Forest Hill Elementary School HVAC Upgrade 2027-752
LAGC Plan Room - North

**ADDENDUM #1
CADDY PARISH SCHOOL BOARD
FOREST HILL ELEMENTARY SCHOOL
HVAC UPGRADE
CPSB PROJECT NO. 2027-752
AFJMc #25-171**

February 2, 2026

S1

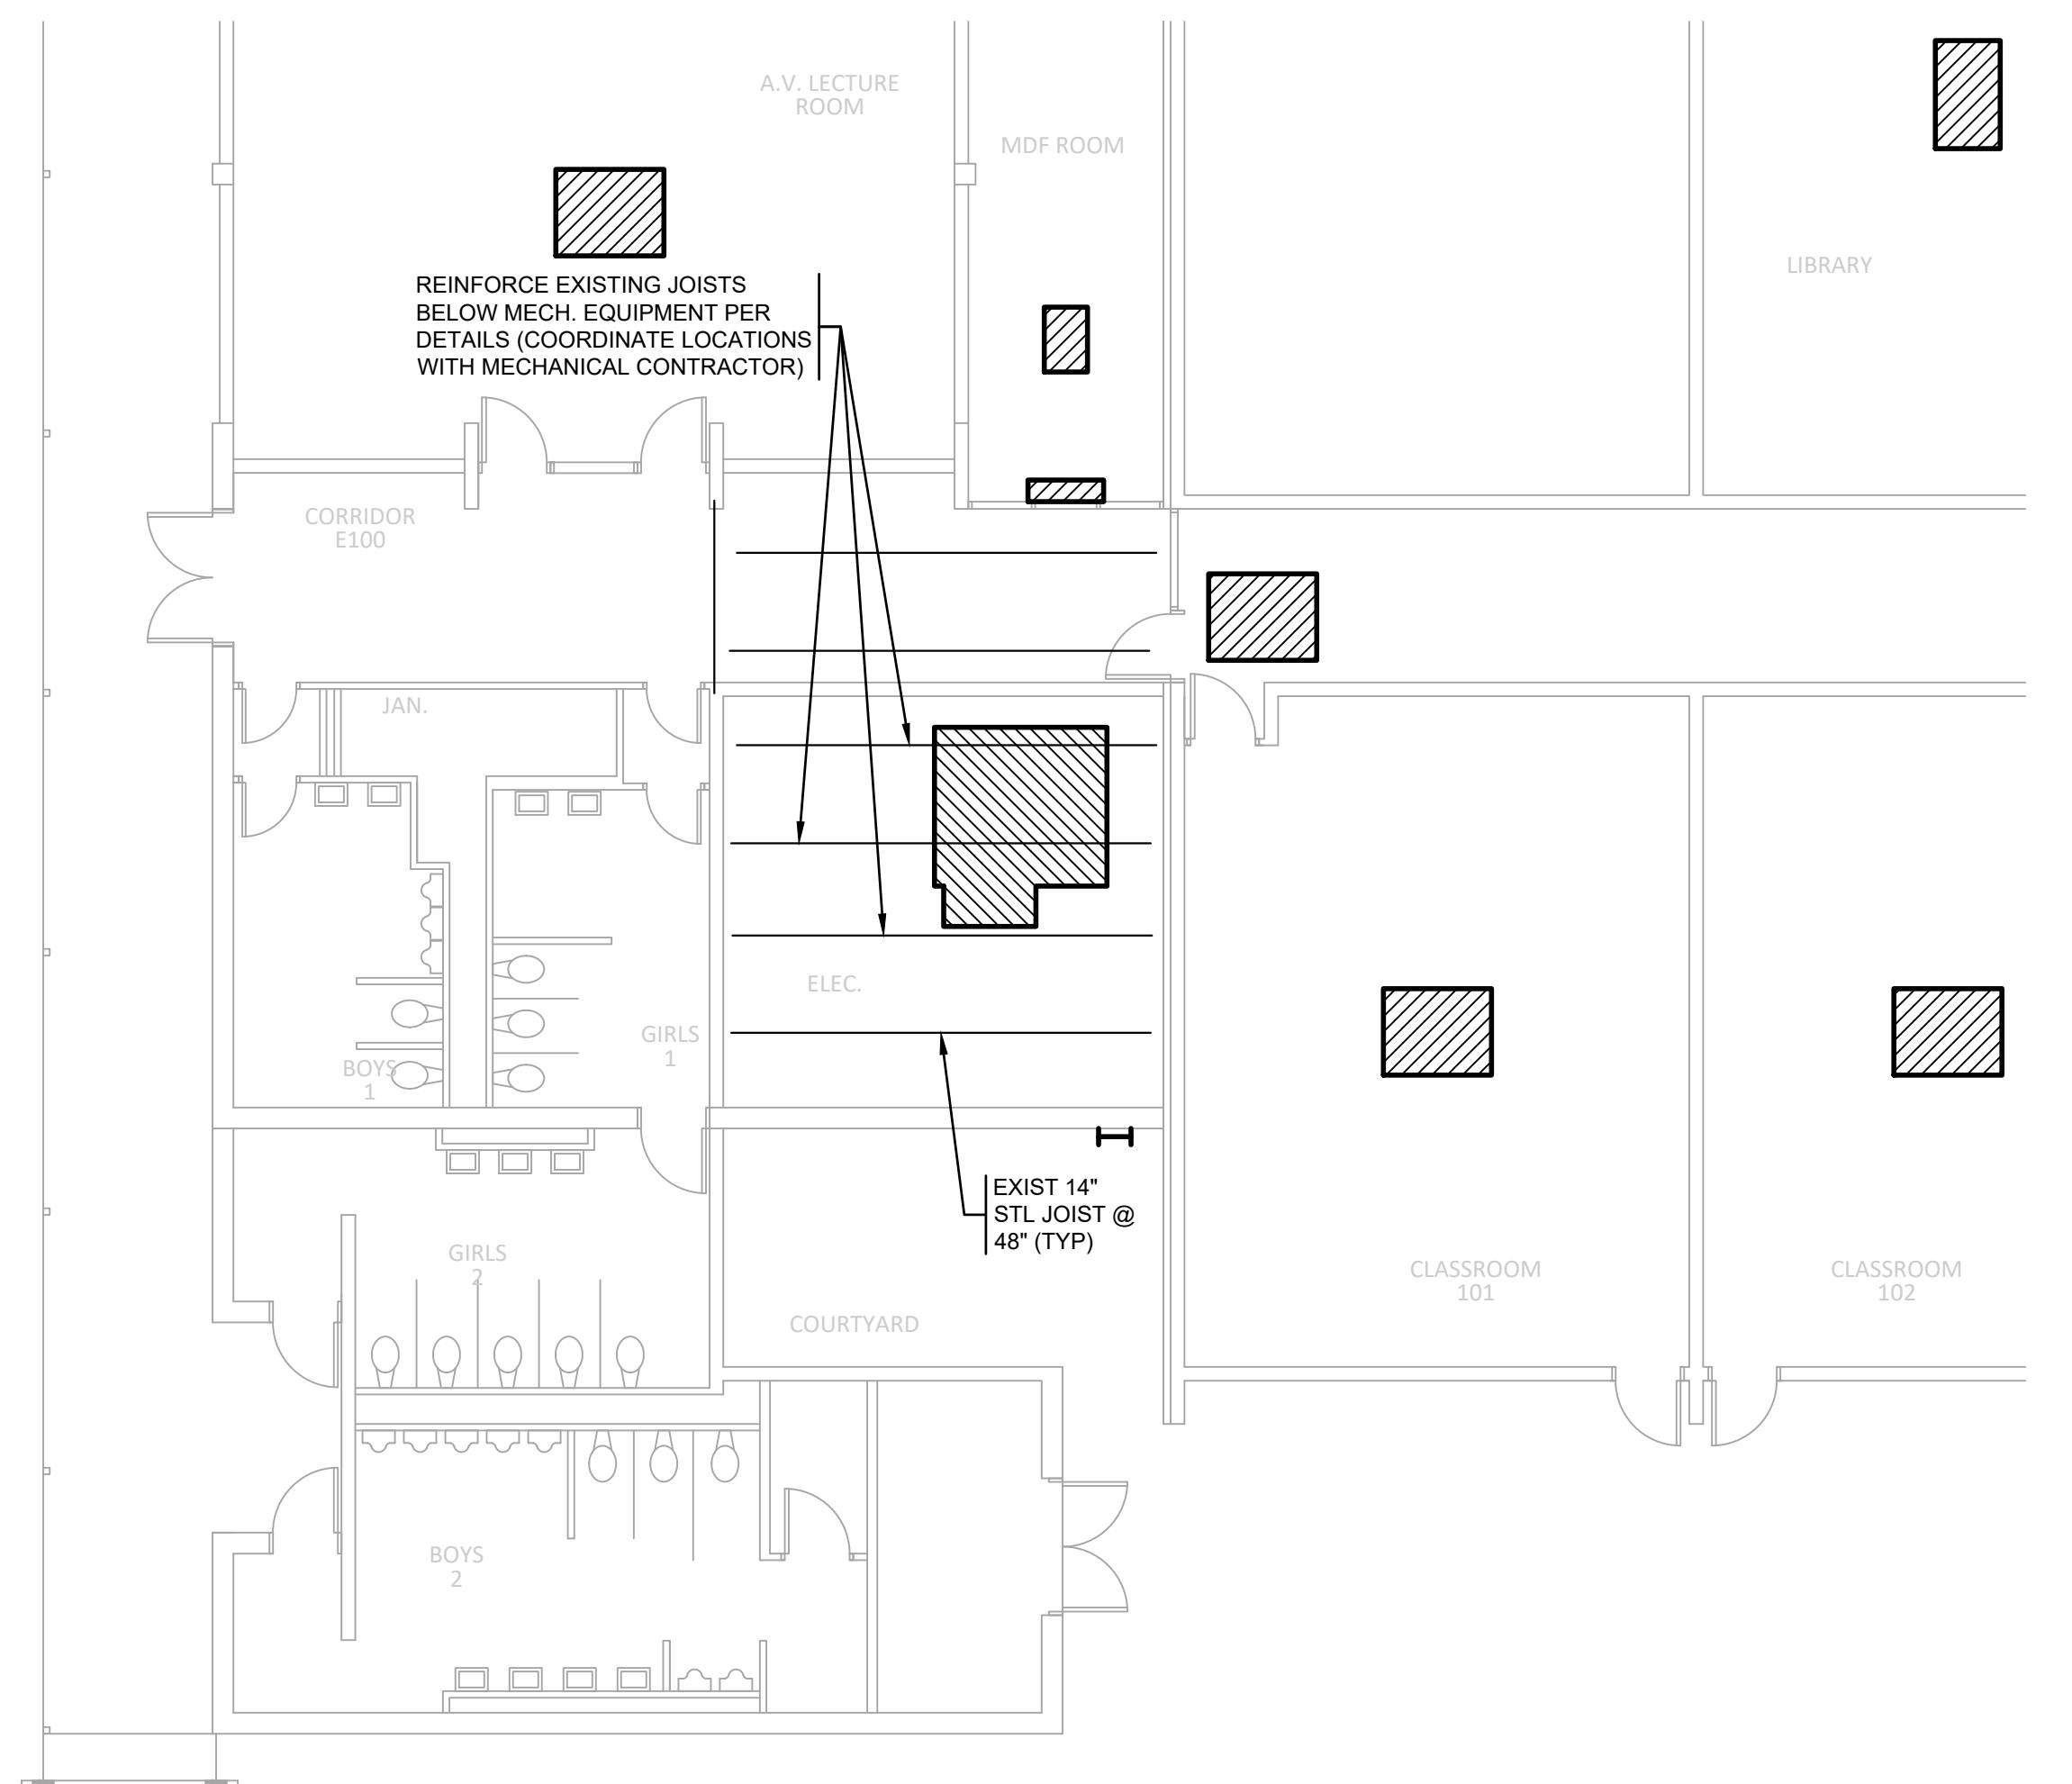
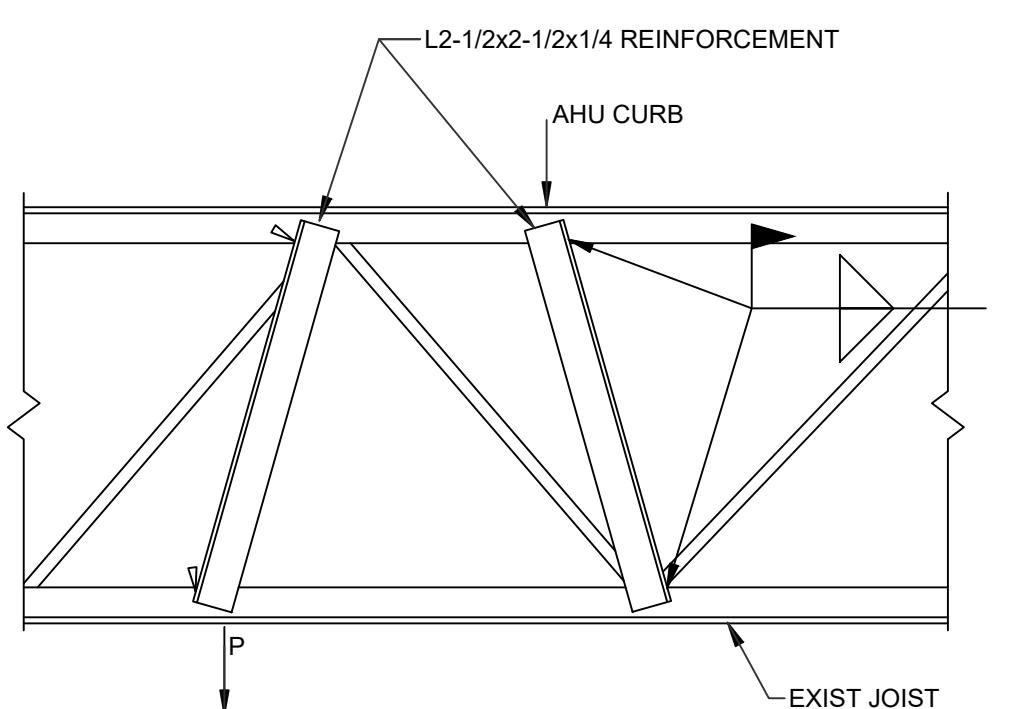
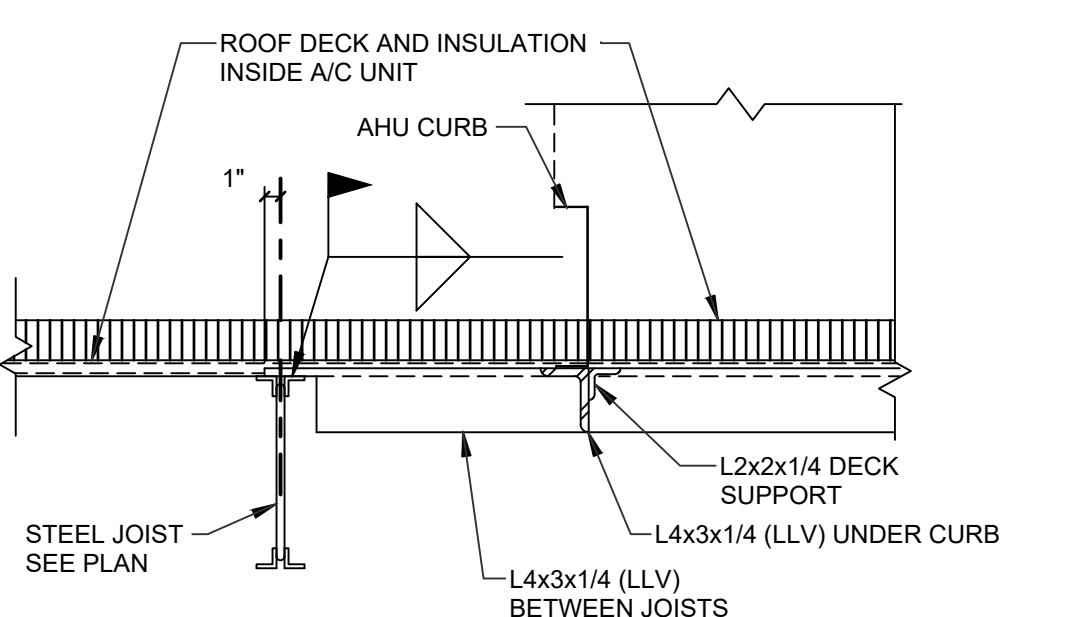
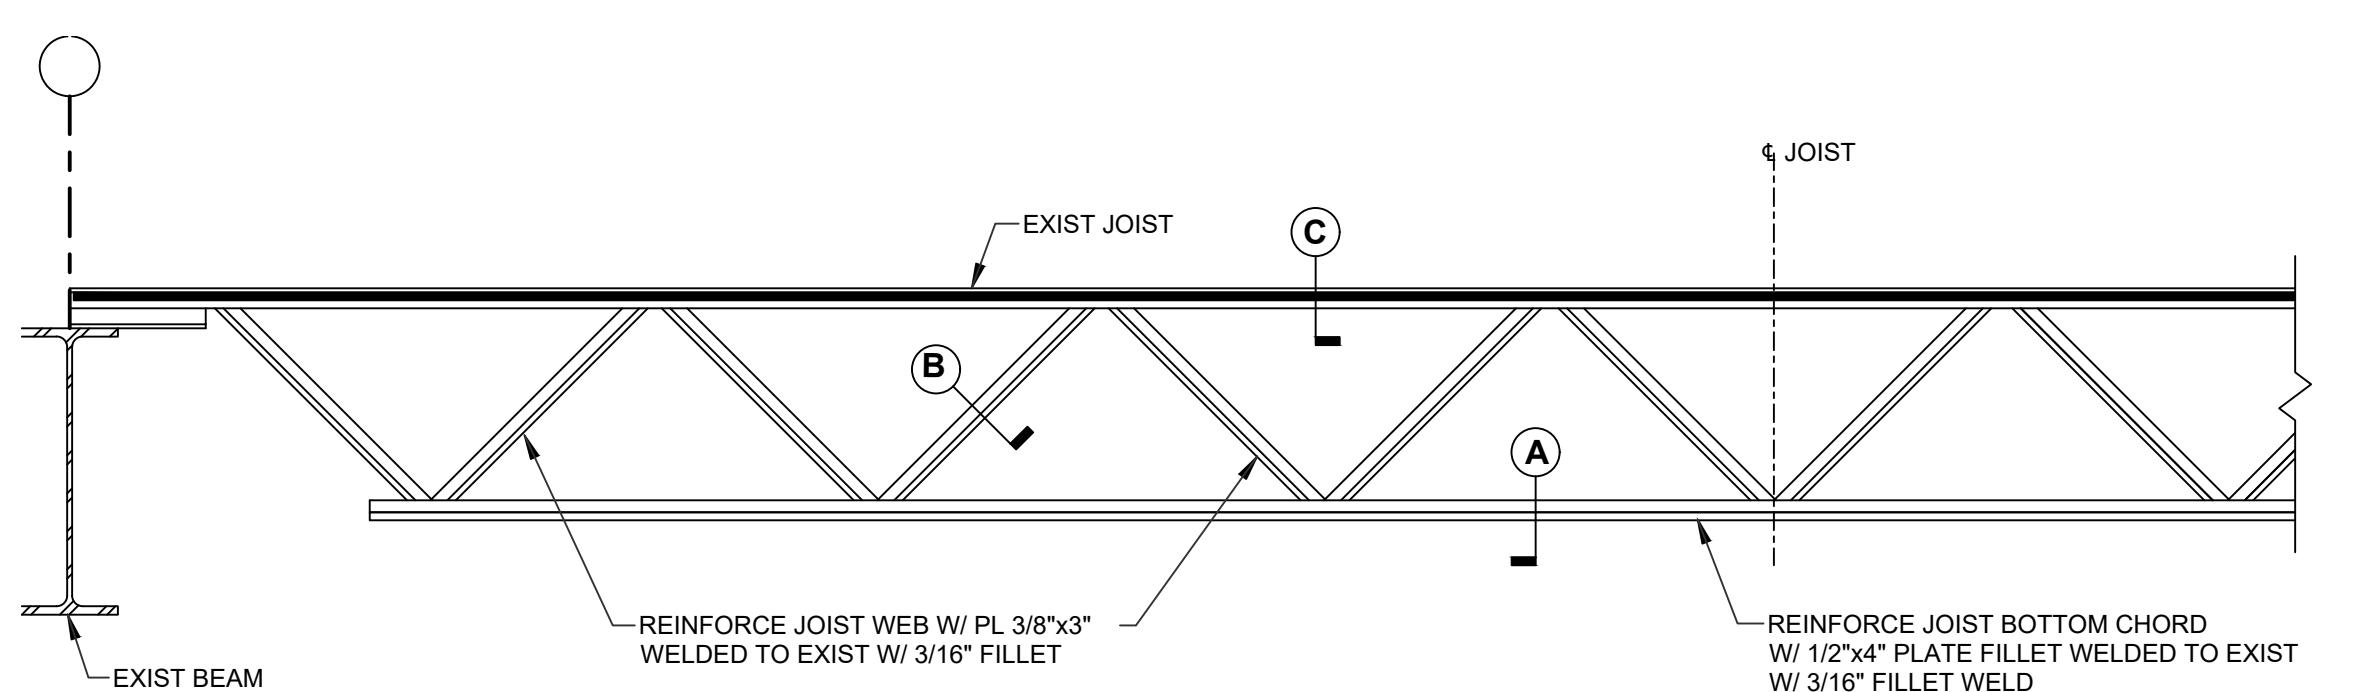
1. Section 00003 Index of Drawings:
 - a. Add sheet S1 Partial Floor Plan Wing "E" Structural Renovation and Details
2. Section 15838 Power Ventilators
 - a. Page 3, item 2.2.F.2 Change minimum curb height to 14"

1. Sheet T1:
 - A. Refer to DRAWING LIST:
 - A. Add sheet S1 - Partial Floor Plan Wing "E" Structural Renovation and Details

5. Sheet M2.3:
 - A. Refer to "Mechanical Note "M7" replace the second and third sentences with the following; "Refer to sheet S1 for structural reinforcement of existing roof framing."

6. Sheet S1
 - A. Add sheet S1 included in this addendum.
